HYUNDAI Technical Service Bulletin

NUMBER
24-01-032HG

MODEL(S)
G80 (DH), G90 (HI)

SUBJECT: TURBO OIL FEED PIPE REPLACEMENT (RECALL 019G)

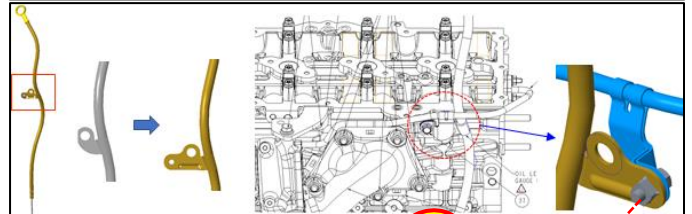
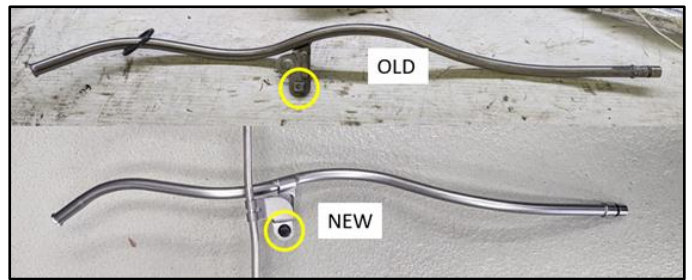
34. Install the newly provided oil level pipe (26612-3LTA1) from the service kit.

- Do not reuse the old oil level pipe.
- When installing the new oil level pipe, lubricate the O-ring to prevent damage.
- Use the existing M10 bolt to fasten the new oil level pipe to the engine first.
- The new LH turbo oil feed pipe will be fastened to the oil level pipe bracket (NN) with the newly supplied M6 bolt.

Tightening Torque (M10 mounting bolt to block):

lb-ft	14.5
N.m	19.7

Tightening Torque (M6 mounting bolt to bracket):

lb-ft	9.4
N.m	12.8

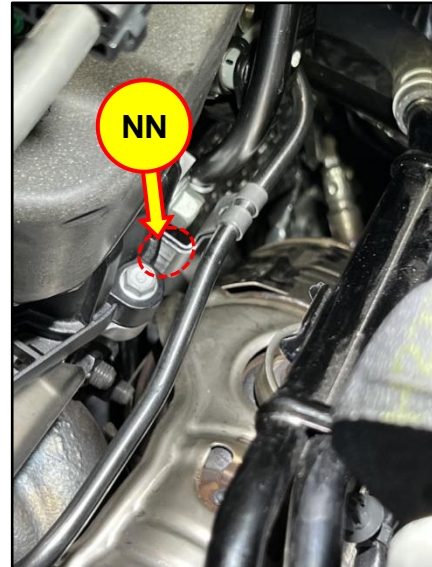
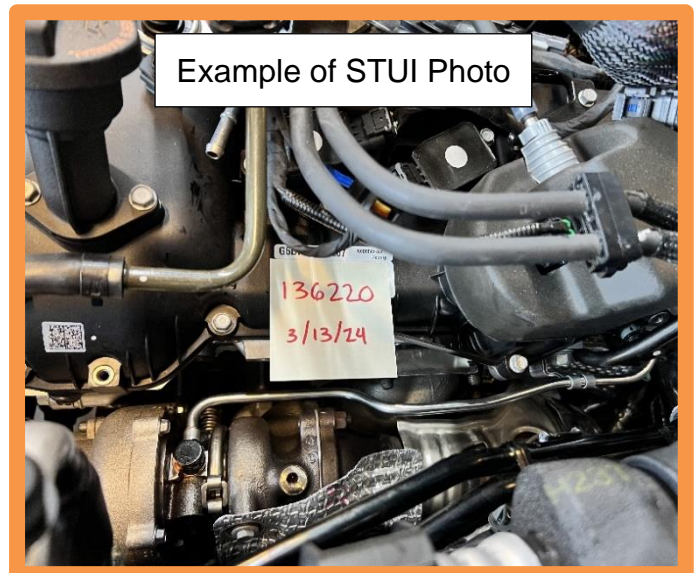
35. Install the new LH turbo oil feed pipe (P/N 28240-3L120) and then position the middle bracket to the oil level guide mounting bracket (NN) to install the M6 mounting bolt.

When installing the new LH turbo oil feed pipe, replace the 2 copper washers and flange gasket with new parts.

Tightening Torque (Eye Bolt):

lb-ft	10.9
N.m	14.8

Tightening Torque (Flange Nuts):

lb-ft	8
N.m	10.8

Tightening Torque (M6 mounting bolt to bracket):

lb-ft	9.4
N.m	12.8
